RFQ NUMBER
GSD096449

LINE	QUANTITY	UOP	CAT NO	ITEM NUMBER	UNIT PRICE	AMOUNT
0001	1	LS		968-42		
ADDENDUM NO. 1 THIS ADDENDUM IS ISSUED TO: 1.) PROVIDE A COPY OF THE MANDATORY PRE-BID ATTENDEE LIST, 2.) ANSWER ALL TECHNICAL QUESTIONS SUBMITTED PRIOR TO THE DEADLINE FOR TECHNICAL QUESTIONS, 3.) ADD REVISED BID FORM (SECTION 00300), 4.) ADD CALENDAR OF EVENTS, AND 5.) ADD THE BELOW DRAWINGS GSD096449: A-2R1A GSD096449: A-2R1B GSD096449: FA-1R1 BID OPENING DATE REMAINS: 04/29/2009 BID OPENING TIME REMAINS: 1:30 PM ***** END ADDENDUM NO. 1 ***** BLDG#9 MUSEUM GIFT SHOP RENOVATIONS

RFQ#GSD096449**Building Nine Museum Gift Shop Renovations****Technical Question & Answers**

STATE MUSEUM SHOP
 Charleston, West Virginia

DWG. NO.
 A-2R1A

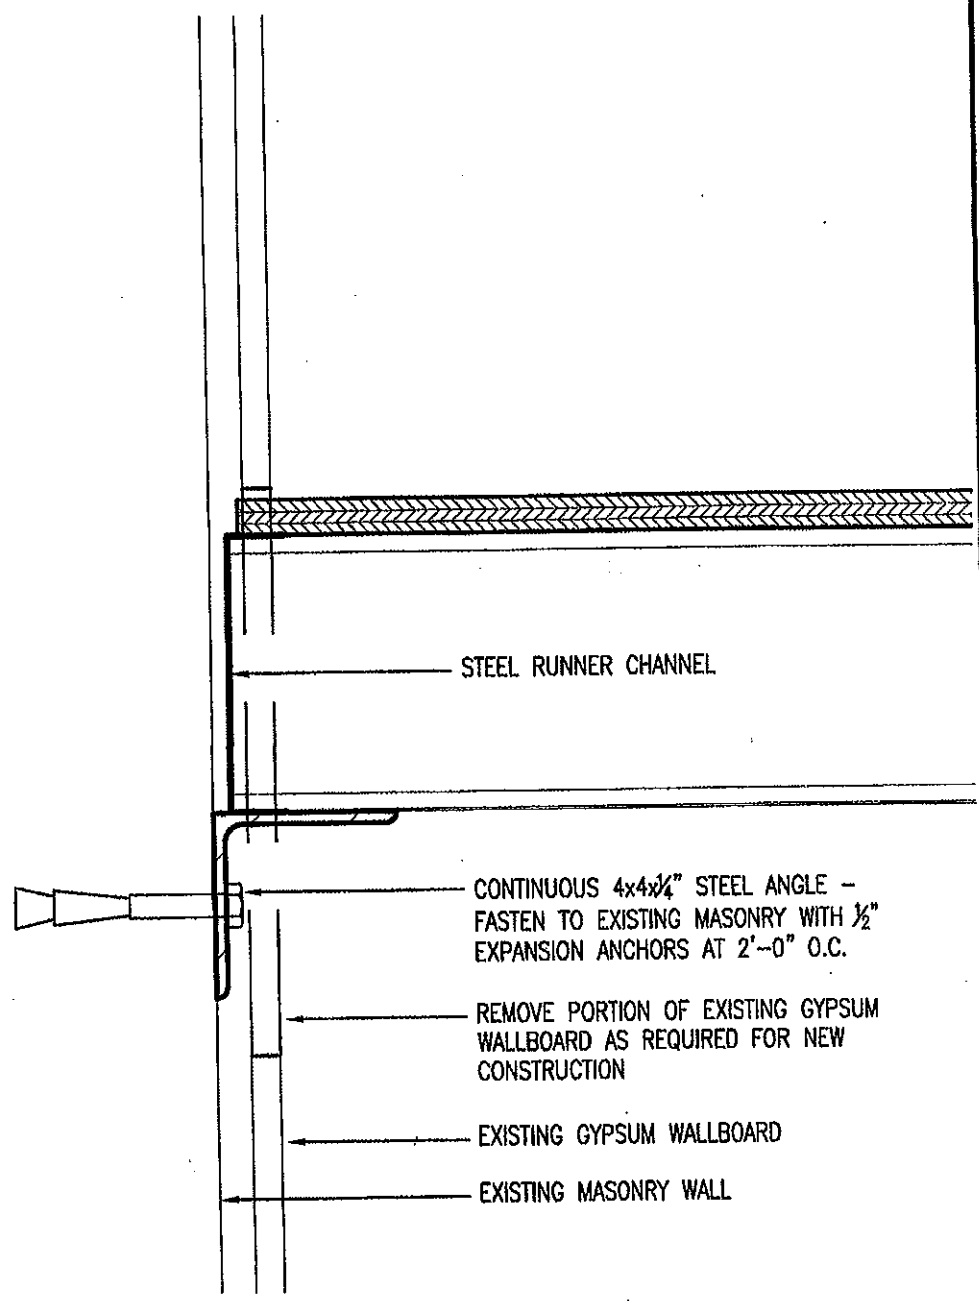
A SECTION
 1/8" = 1'-0"

- NEW DRAWING or DETAIL _____ on sheet _____
- REVISION OF DRAWING or DETAIL A on sheet A-2
- CLARIFICATION OF DRAWING or DETAIL _____ on sheet _____
